# Service Bulletin

**SUBJECT:** Service Update for Inventory and Customer Vehicles  
Front Seat Mounted Speaker Buzz  
Expires with Base Warranty

**MODELS:** 2013 Cadillac XTS  
Equipped with Front Seat Mounted Speakers (UQS)

Subject: 13004 – Service Update Bulletin  
Front Seat Mounted Speaker Buzz

3289561

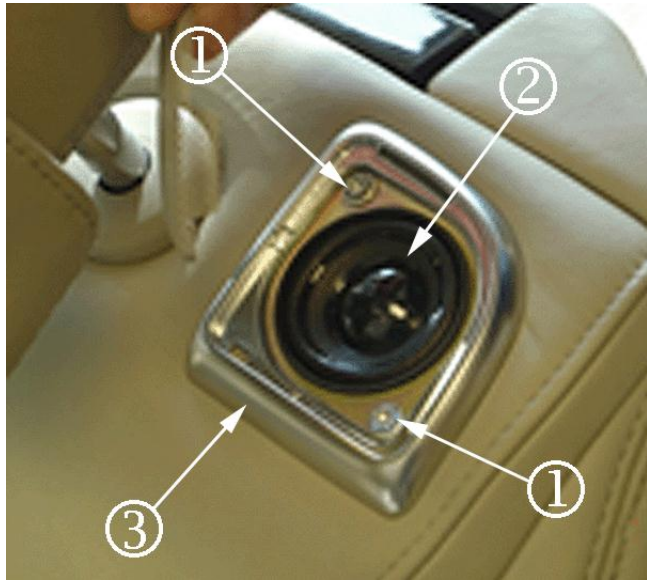
This bulletin provides a service procedure to replace the fasteners and the bezel for the front seat mounted speakers on **certain** 2013 model year Cadillac XTS that are equipped with front seat mounted speakers (UQS). The fasteners may lose clamp load and cause a buzz noise, especially when listening to stations with talk radio.

1. Insert a pick into the speaker hole at the rear of the grille towards the center of the seat. Pry up the grille at the front then move towards the outboard side of the grille. Use a small prying object under the pick so not to damage the speaker bezel.
2. Remove the speaker attachment screws.

3. Remove the speaker.
4. Remove the speaker bezel.

5. Install the new speaker bezel (3).

6. Install the speaker (2).

7. Install the new speaker attachment screws (1). **Tighten screws to 1.1 N-m (9.7 lb in).**
